<b>Subject:</b>  NOISE FROM REAR BRAKES DUE TO BRAKE DRAG	<b>Bulletin No:</b> 04-005/16
	<b>Last Issued:</b> 08/05/2016

2016 CX-5 vehicles with VINs lower than JM3KE\*\*\*\*\*781350 (produced before Feb. 22, 2016)

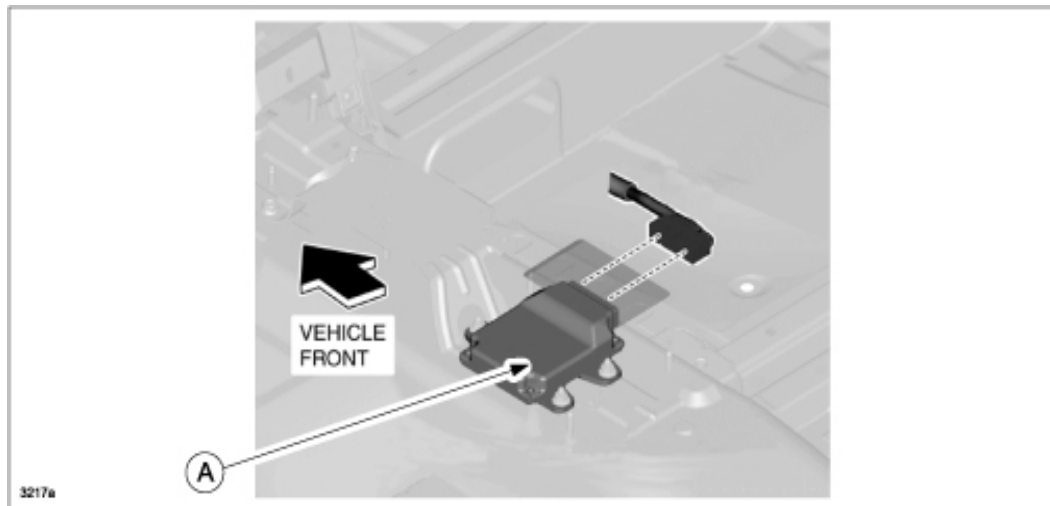
Some vehicles may exhibit rear brake dragging, resulting in brake noise and abnormal outer brake pad wear.

This may be caused when the Electronic Parking Brake (EPB) does not release completely. To eliminate this concern, the EPB control module logic has been modified.

1. Verify the customer concern.
2. Replace the electric parking brake control module (A) with a modified one according to the instructions on MS3 online (ELECTRIC PARKING BRAKE CONTROL MODULE REMOVAL/INSTALLATION).
